7/21/21	<span style="color:red">6</span> Added Removal of Existing Delineators
7/14/21	<span style="color:red">4</span> Added Clear & Grub Limits
DATE	REVISION
STATE OF HAWAII DEPARTMENT OF TRANSPORTATION HIGHWAYS DIVISION	
<b>DEMOLITION AND EROSION CONTROL</b>	
<b>INTERSTATE ROUTE H-1 RESURFACING</b>	
Miller Pedestrian Overpass to Kapiolani Interchange	
Federal-Aid Project No. NH-HI-1(279)	
Scale: 1" = 40'	
Date: August 2021	
SHEET No. EC4 OF 23 SHEETS

<b>DEMOLITION AND EROSION CONTROL</b>	
INTERSTATE ROUTE H-1 RESURFACING	
Miller Pedestrian Overpass to Kapiolani Interchange	
Federal-Aid Project No. NH-HI-1(279)	
Scale: 1" = 40'	
Date: August 2021	
SIGNATURE	04/30/22
EXPIRATION DATE OF THE LICENSE	
SHEET No. EC7 OF 23 SHEETS

DEMOLITION AND EROSION CONTROL	
<u>INTERSTATE ROUTE H-1 RESURFACING</u>	
<u>Miller Pedestrian Overpass to Kapiolani Interchange</u>	
Federal-Aid Project No. NH-HI-1(279)	Date: August 2021
Scale: 1" = 40'	
SHEET No. EC8 OF 23 SHEETS

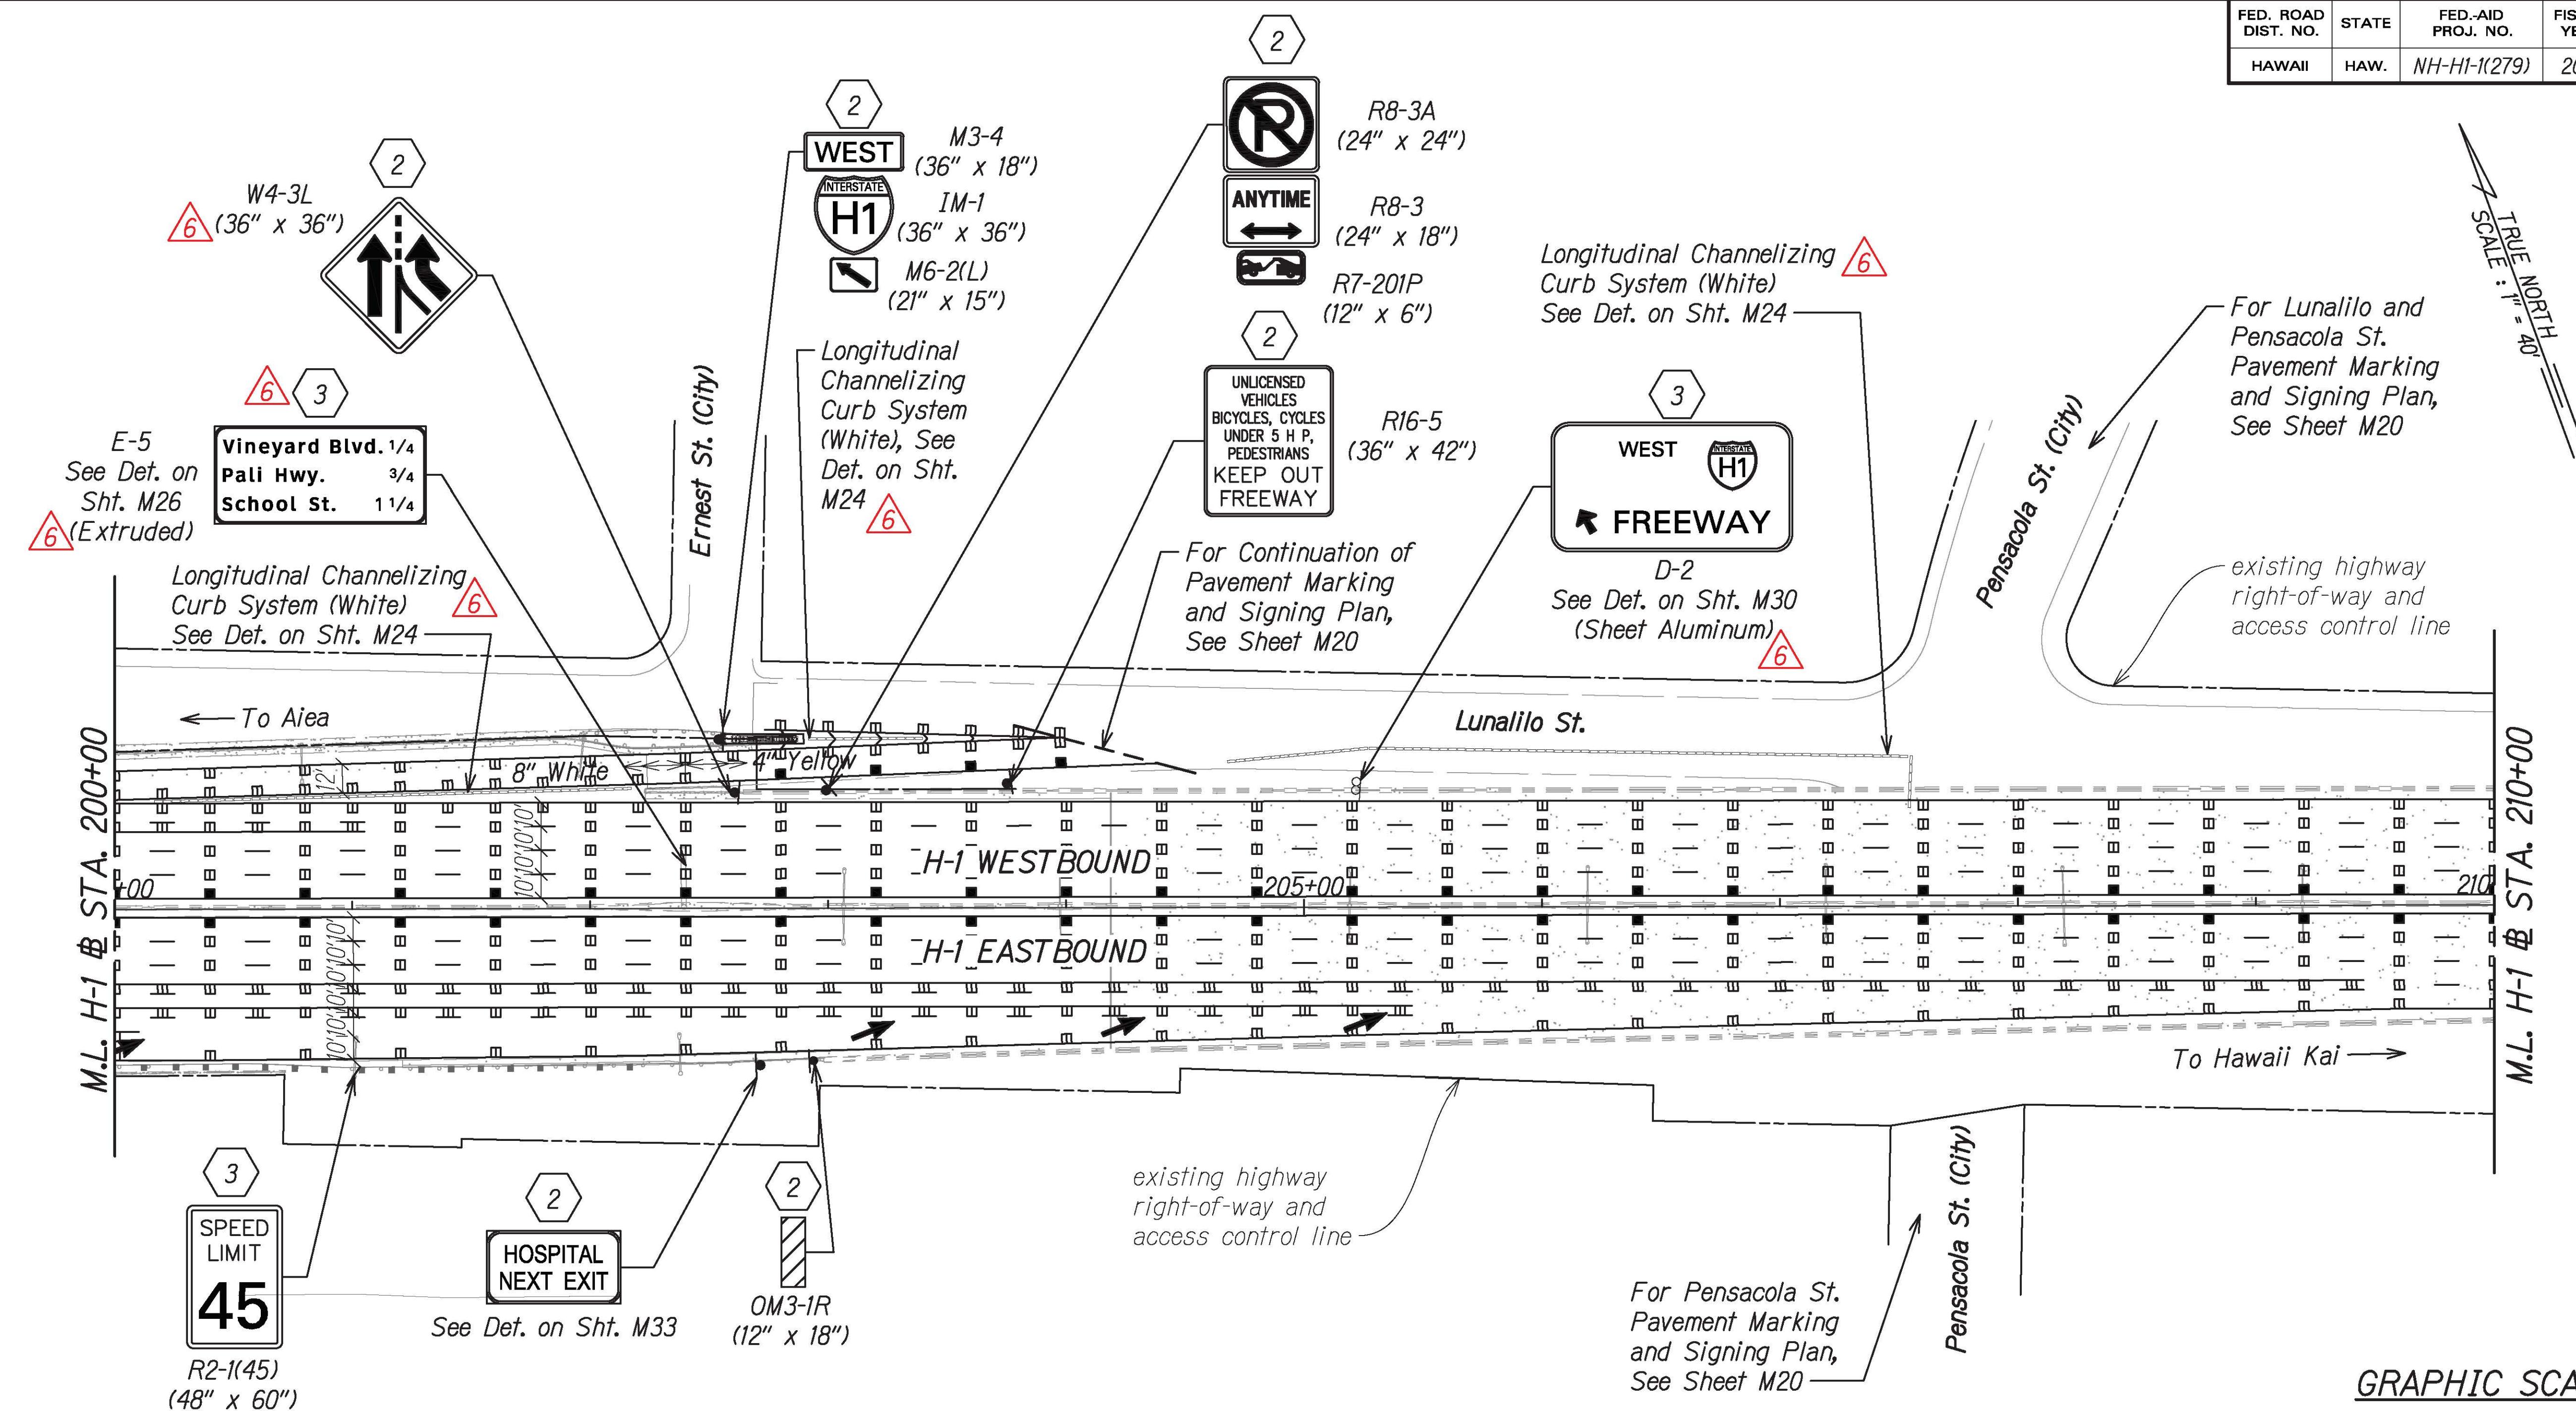
7/21/21	Removed Signing Key No. 10, <b>(6)</b> Updated Sign Size and Updated Reference Note and Callout
DATE	REVISION
<b>PAVEMENT MARKING &amp; SIGNING PLAN</b> <b>INTERSTATE ROUTE H-1 RESURFACING</b> Miller Pedestrian Overpass to Kapiolani Interchange Federal-Aid Project No. NH-HI-1(279) Scale: 1" = 40' Date: August 2021 SHEET No. M5 OF 34 SHEETS

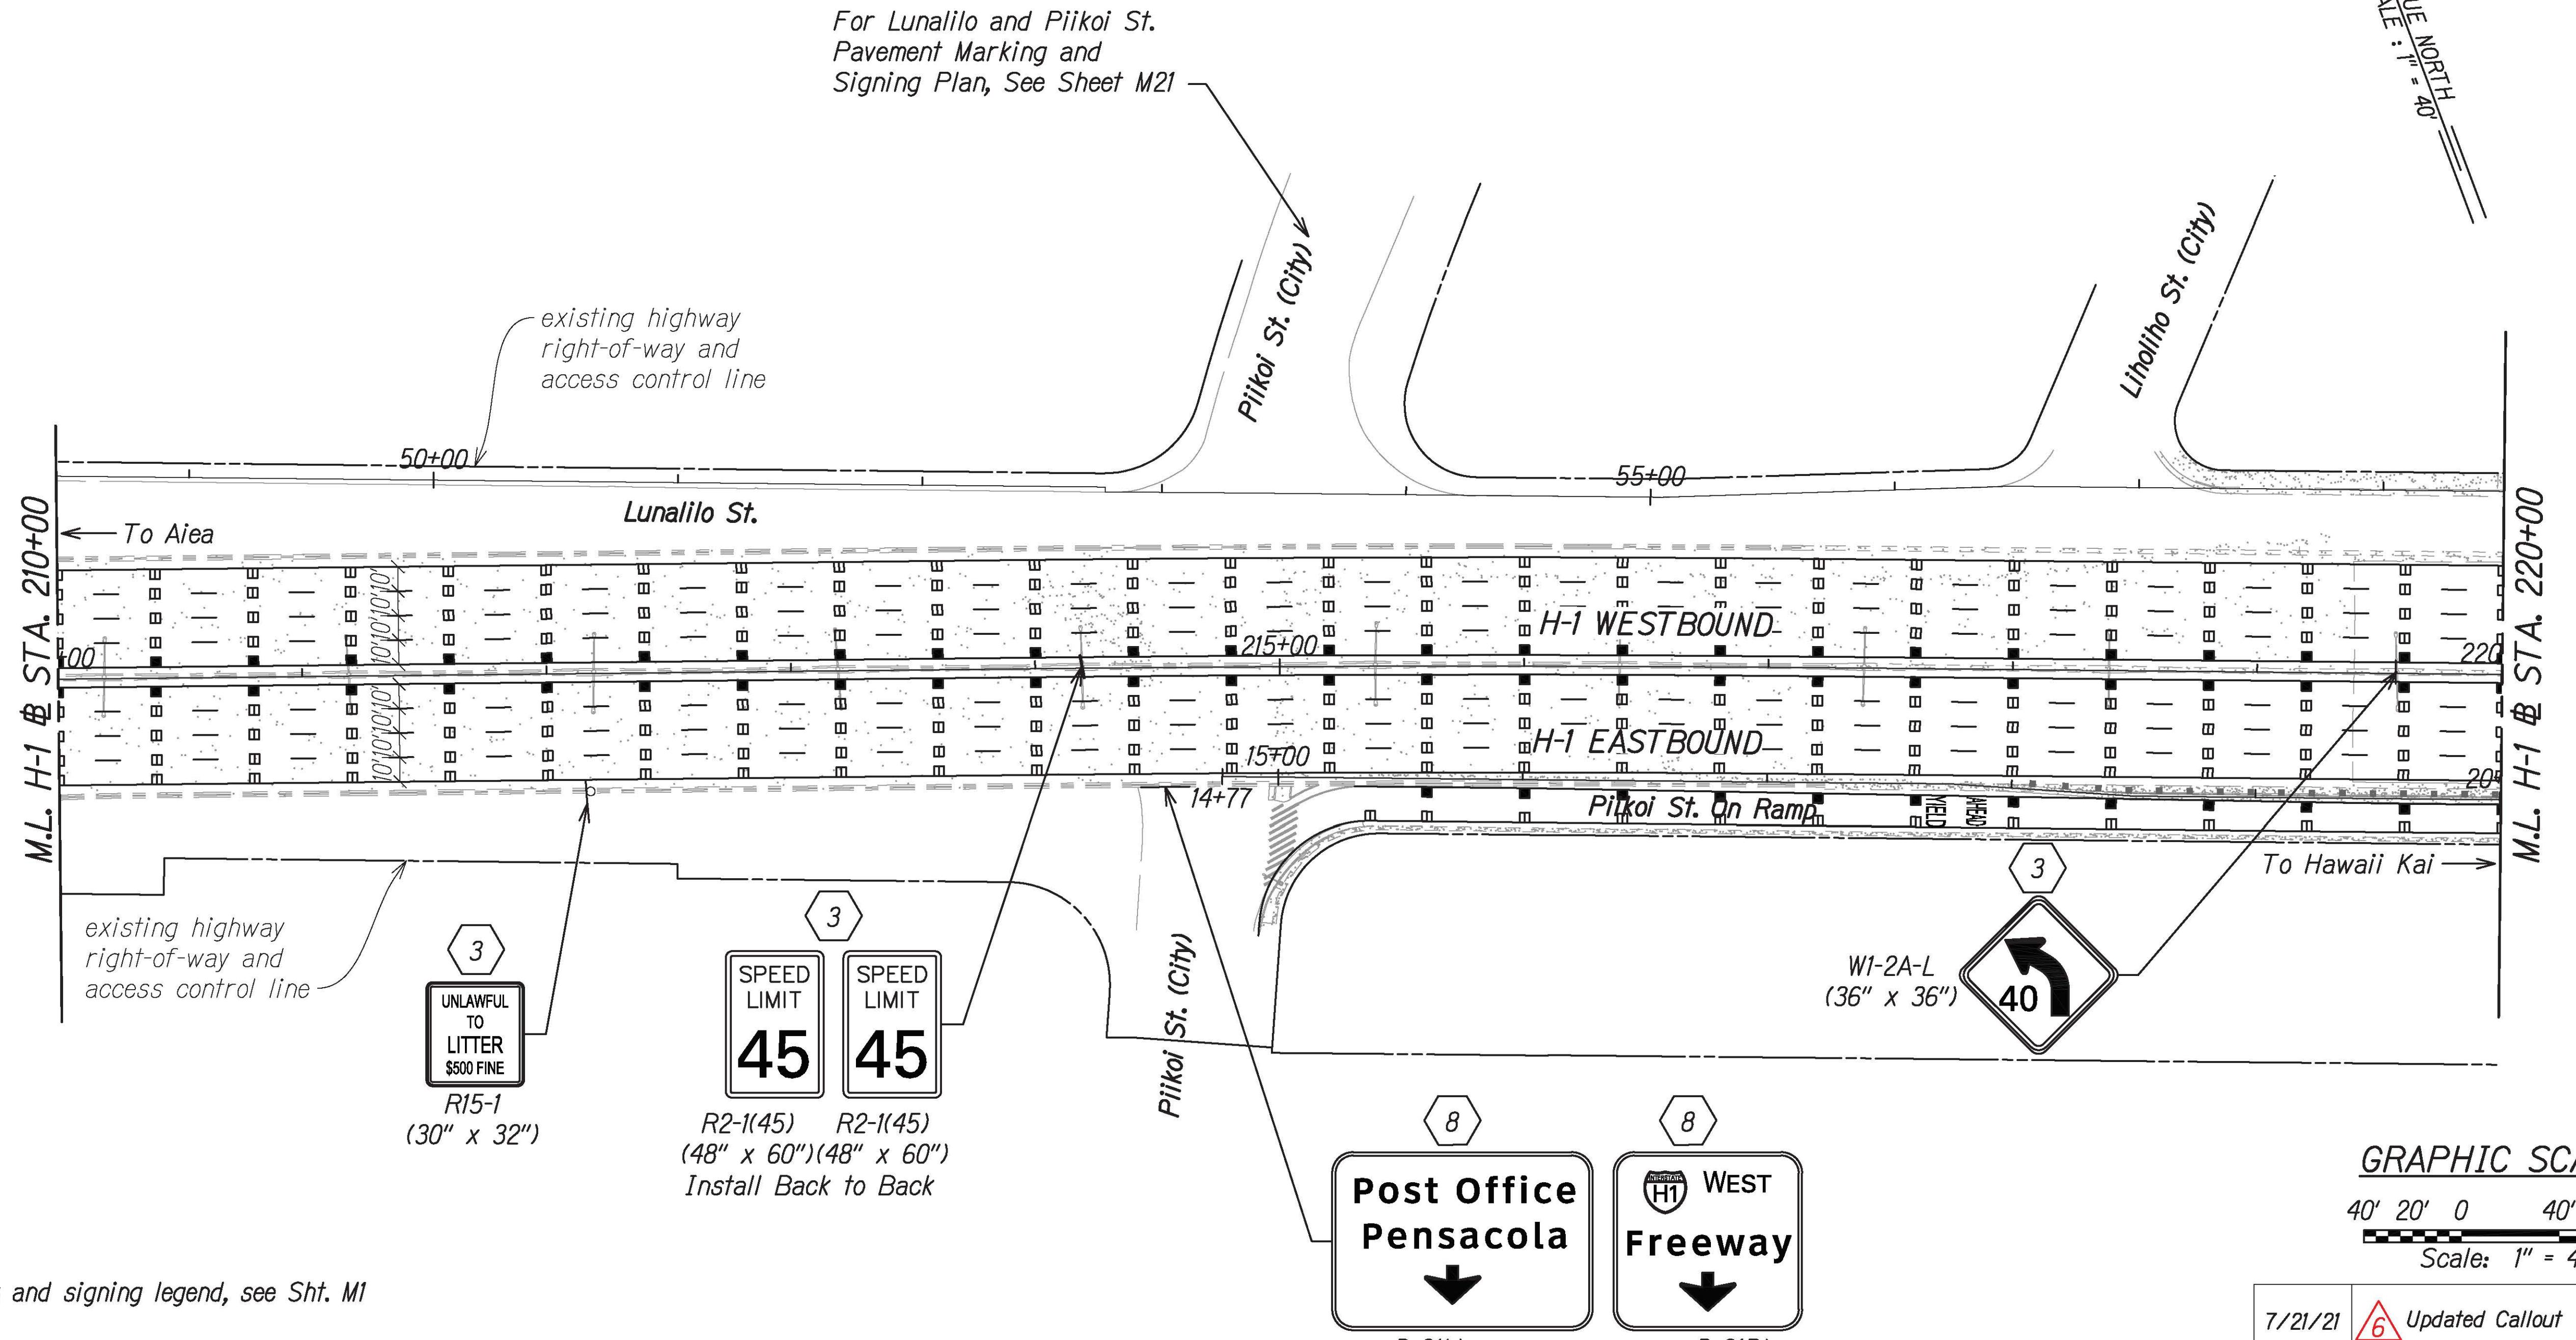
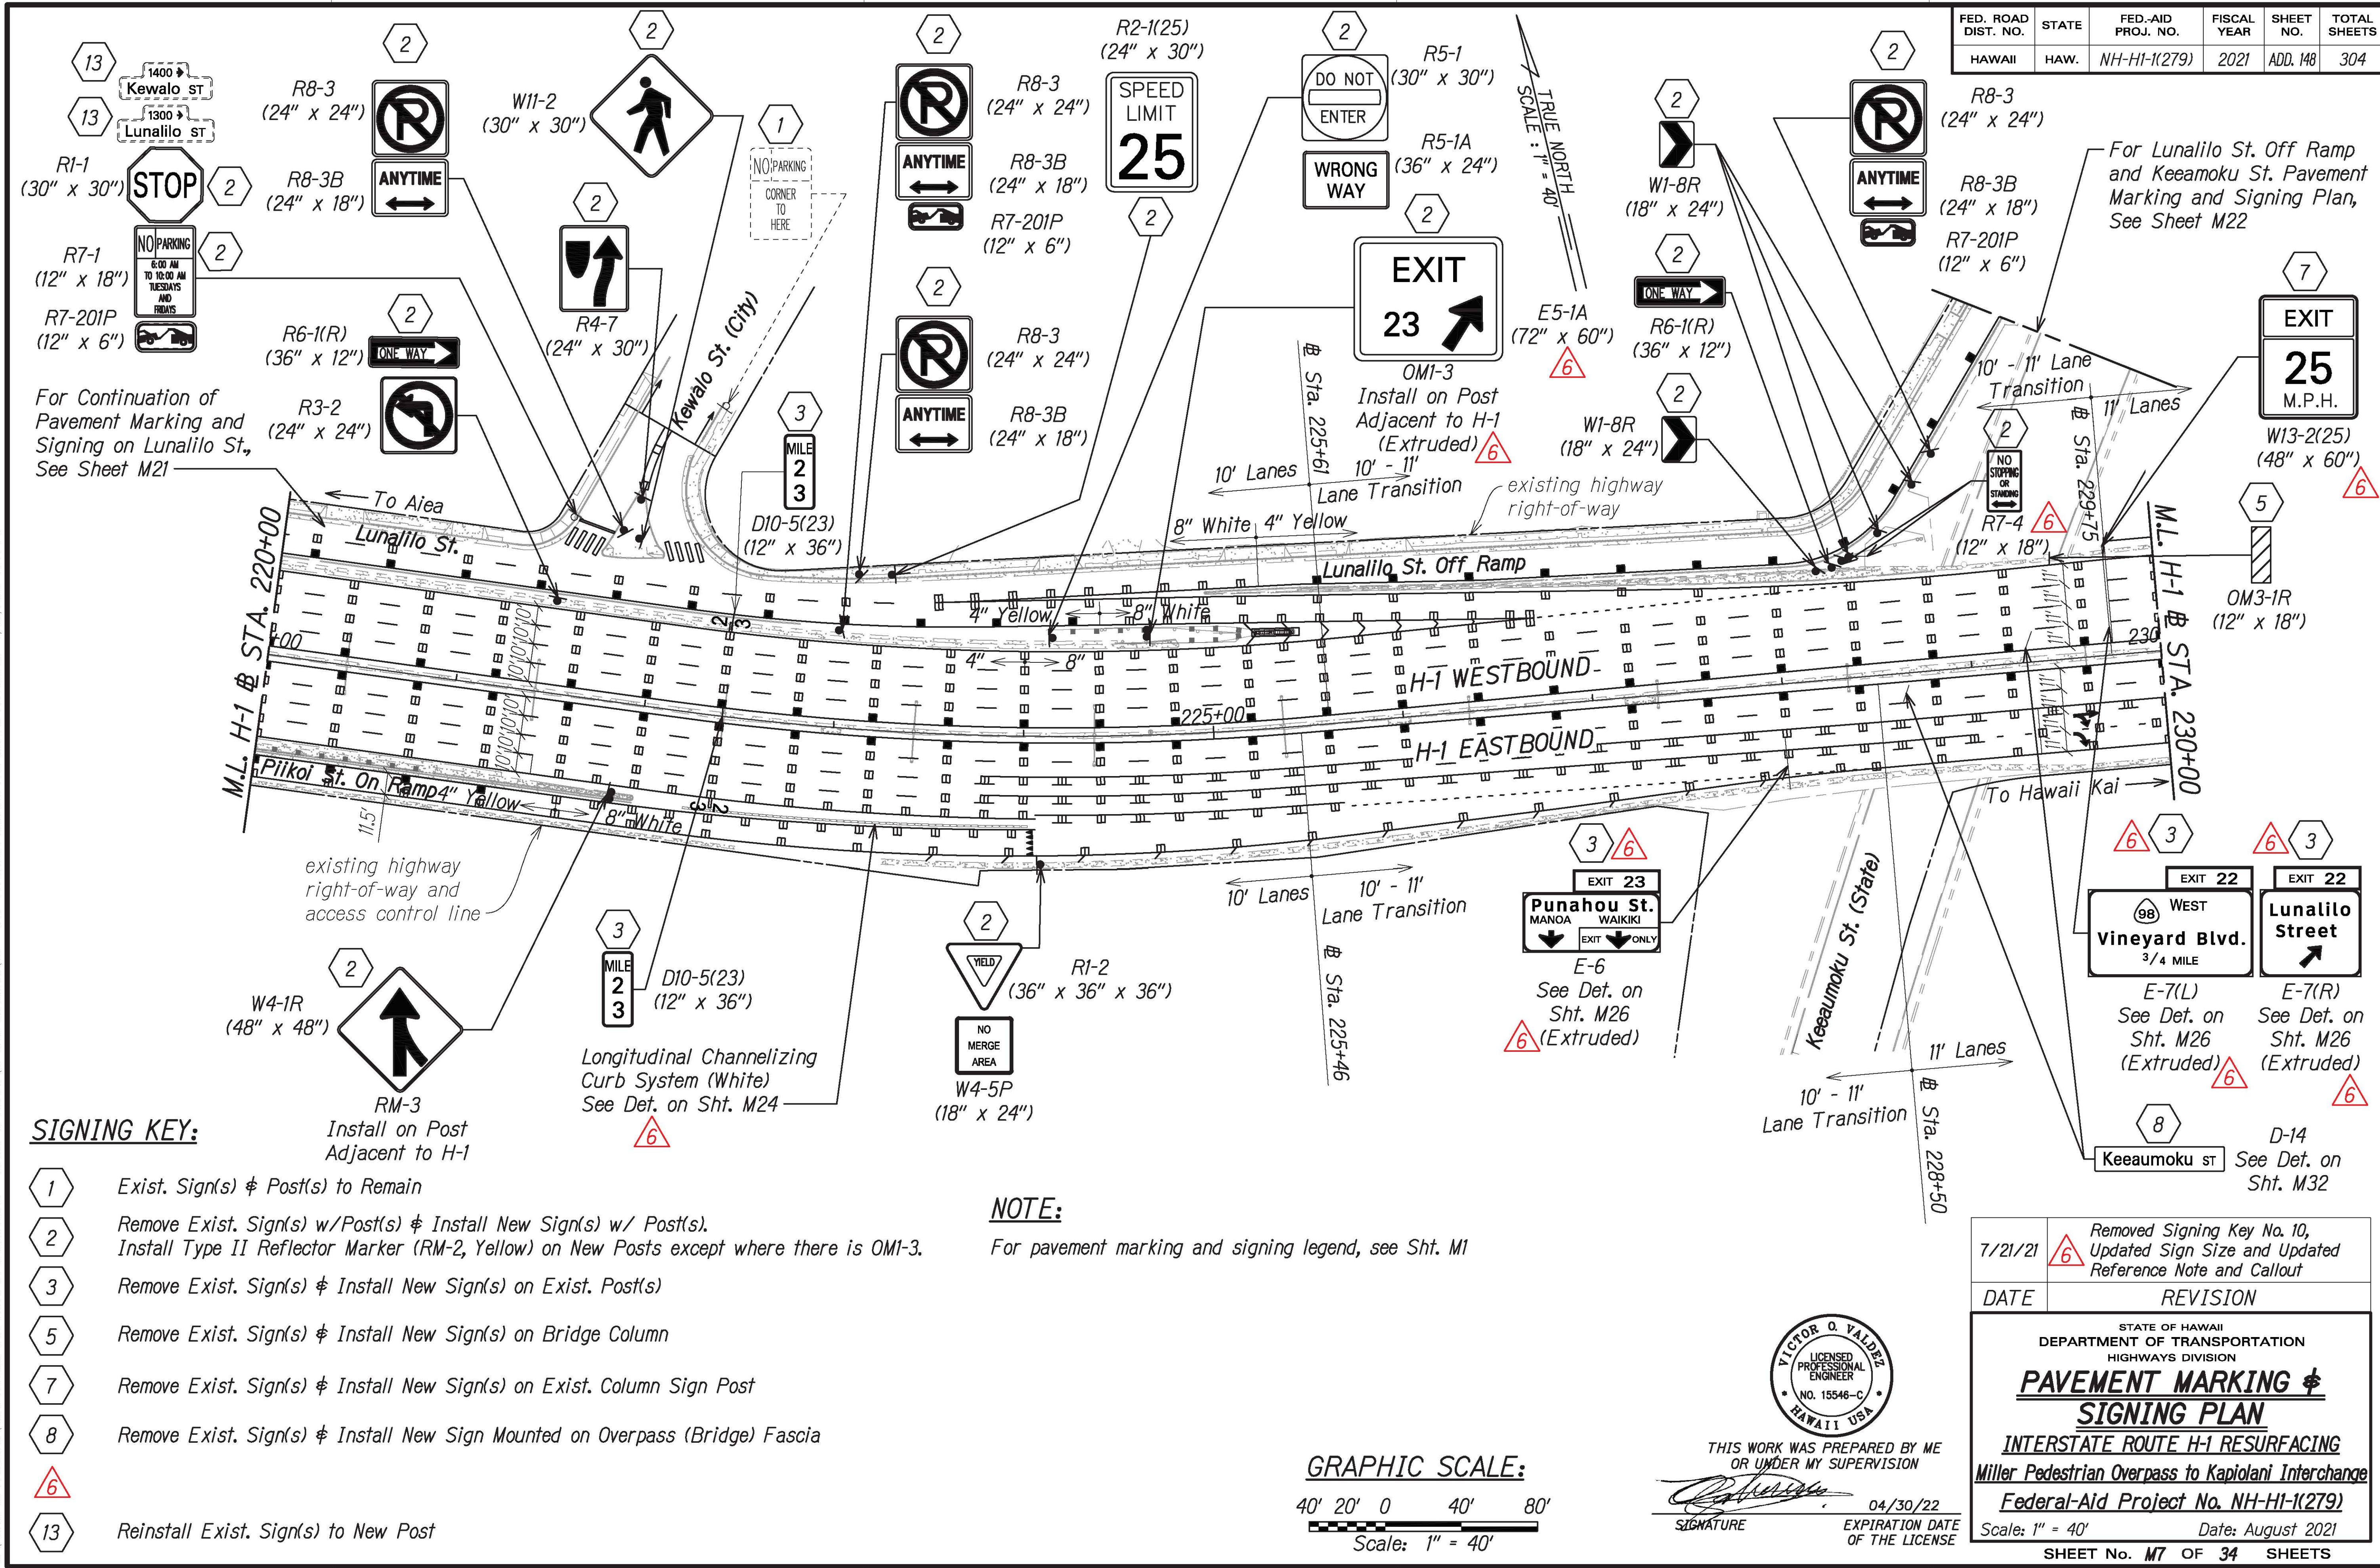
7/21/21	6 Updated Callout
DATE	REVISION
STATE OF HAWAII DEPARTMENT OF TRANSPORTATION HIGHWAYS DIVISION	
<b>PAVEMENT MARKING &amp; SIGNING PLAN</b>	
INTERSTATE ROUTE H-1 RESURFACING	
Miller Pedestrian Overpass to Kapiolani Interchange	
Federal-Aid Project No. NH-HI-1(279)	
Scale: 1" = 40'	
Date: August 2021	
SHEET NO. M6 OF 34 SHEETS
